**Re: Stormwater Sampling and Analysis Plan – Revision 1
Akron Airdock, Akron, Ohio
Voluntary Action Program (VAP)**

**STORMWATER SAMPLING
AND ANALYSIS PLAN – REVISION 1**

Akron Airdock Facility
1210 Massillon Road
Akron, Ohio

FIGURE 2
STORM SEWER SYSTEM WITH
FACILITY SAMPLING LOCATIONS

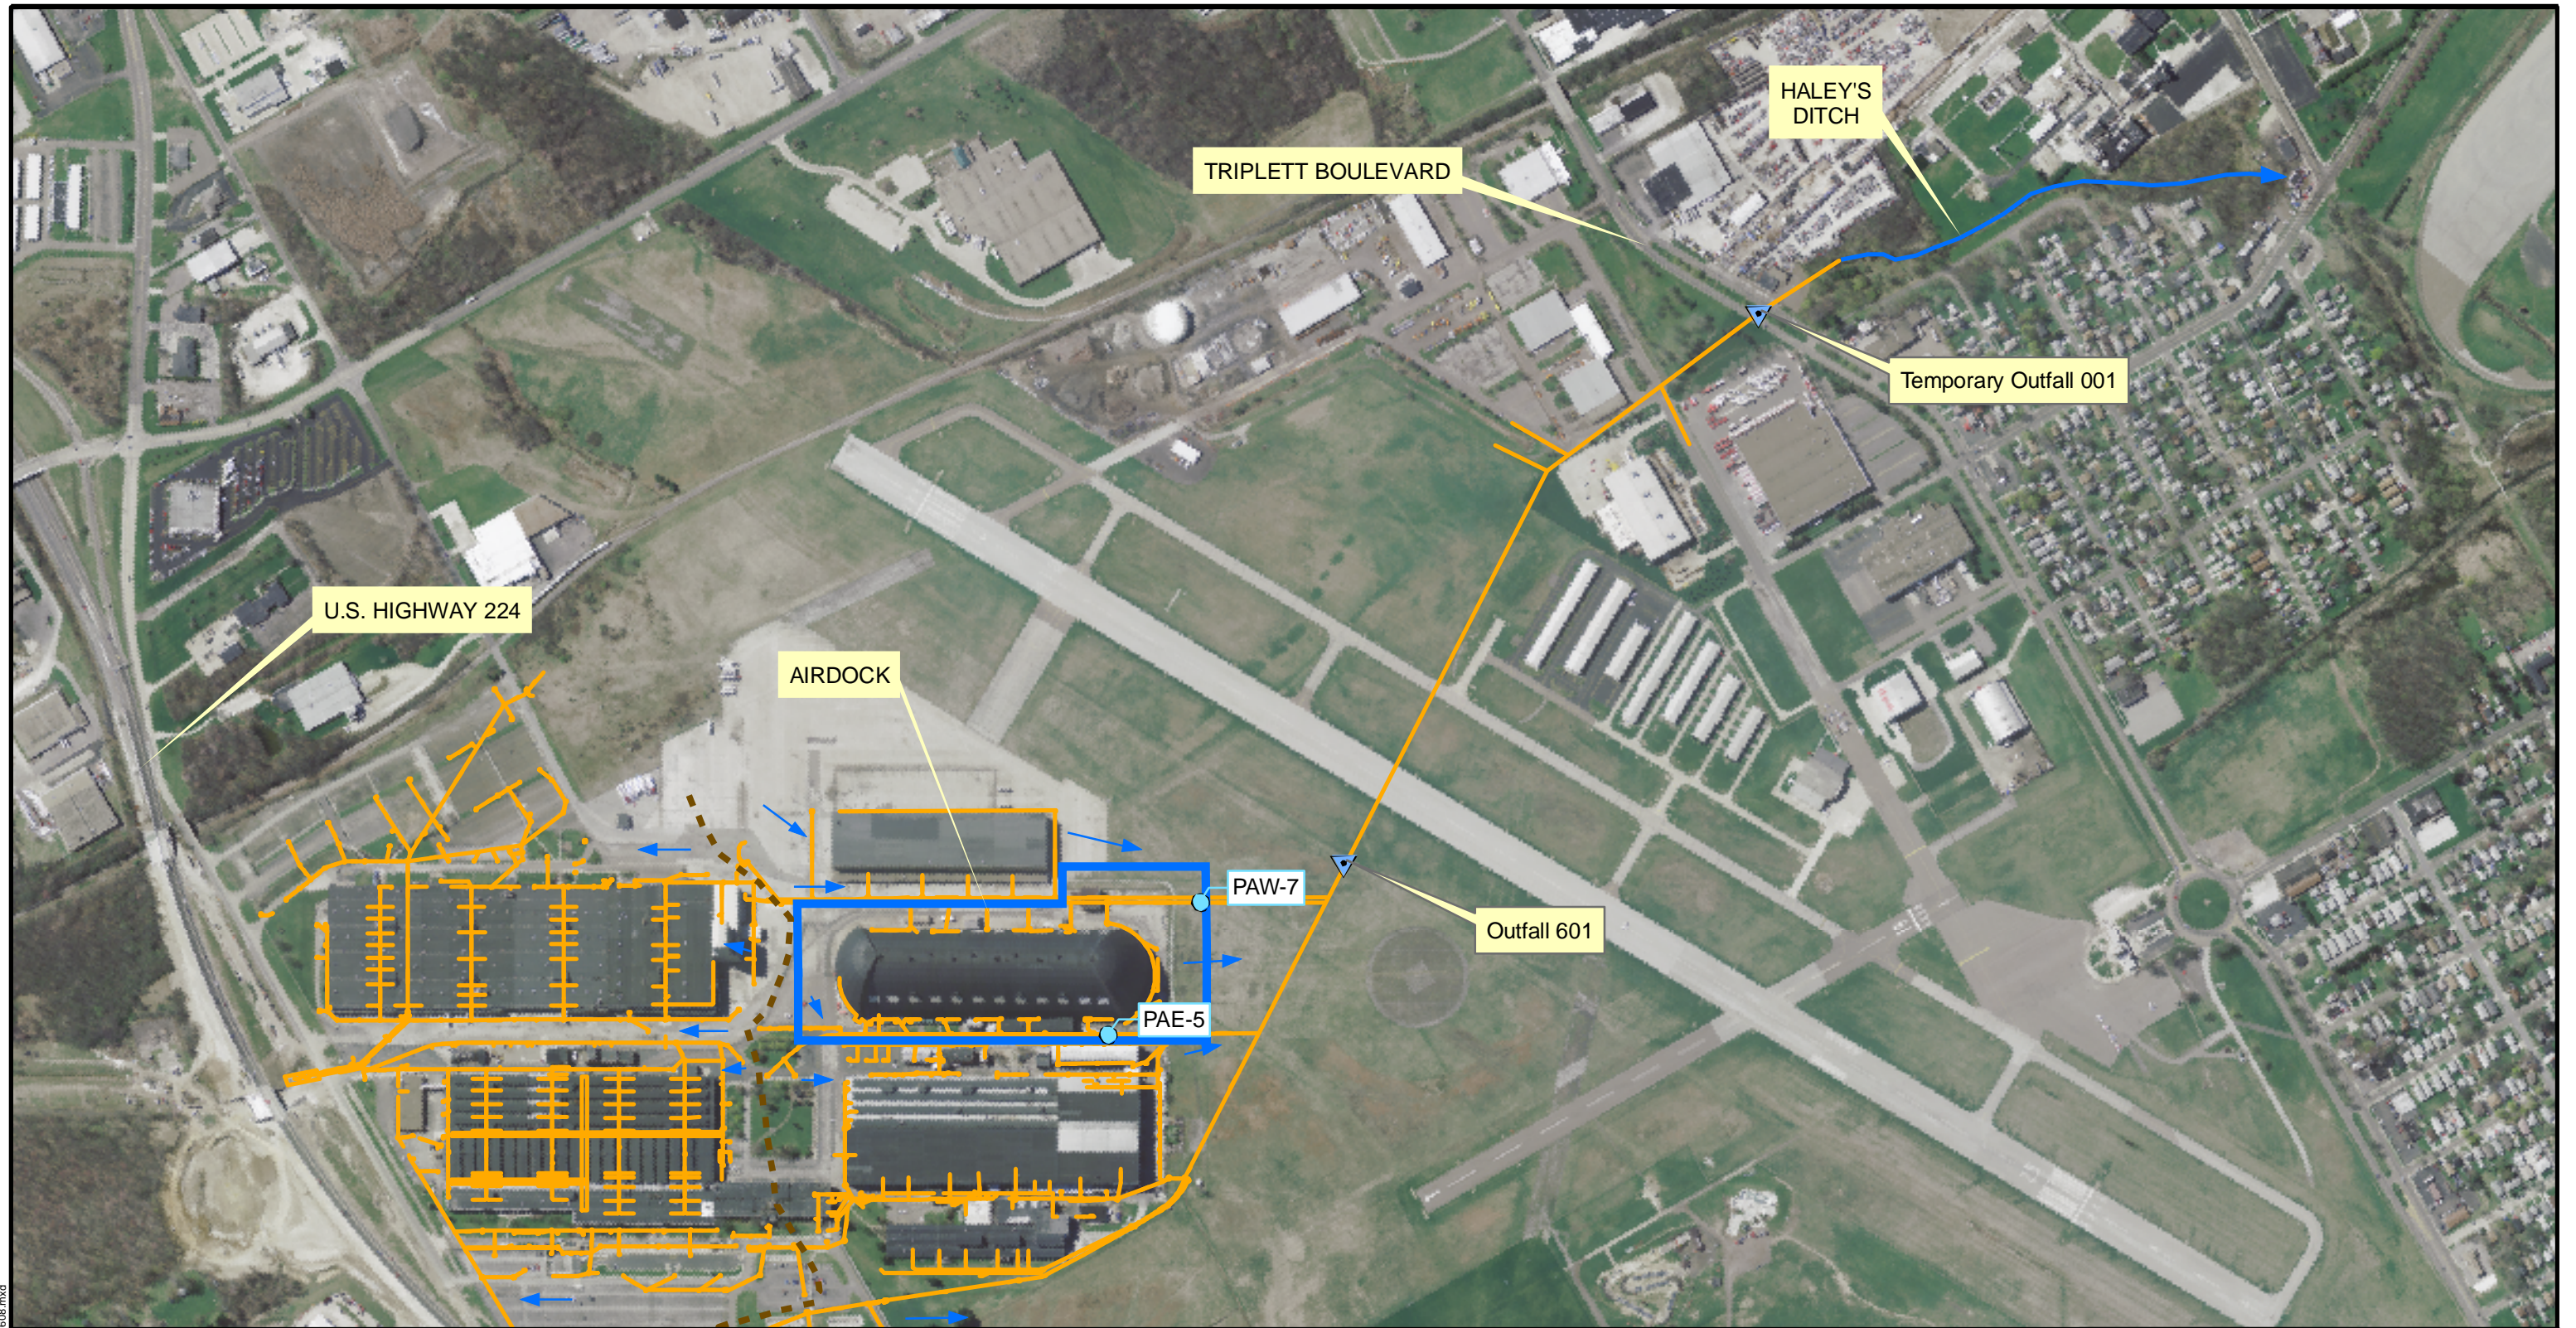
2) Section 4.2.2, Typo: *The last sentence of this section refers to sampling point CBI462 as one of the sampling points. However, Figure 2 shows sampling point CBI492. Please provide the correct numbering for this sampling point.*

Response: CB1462 is the correct sampling point designation. Figure 2 has been corrected.
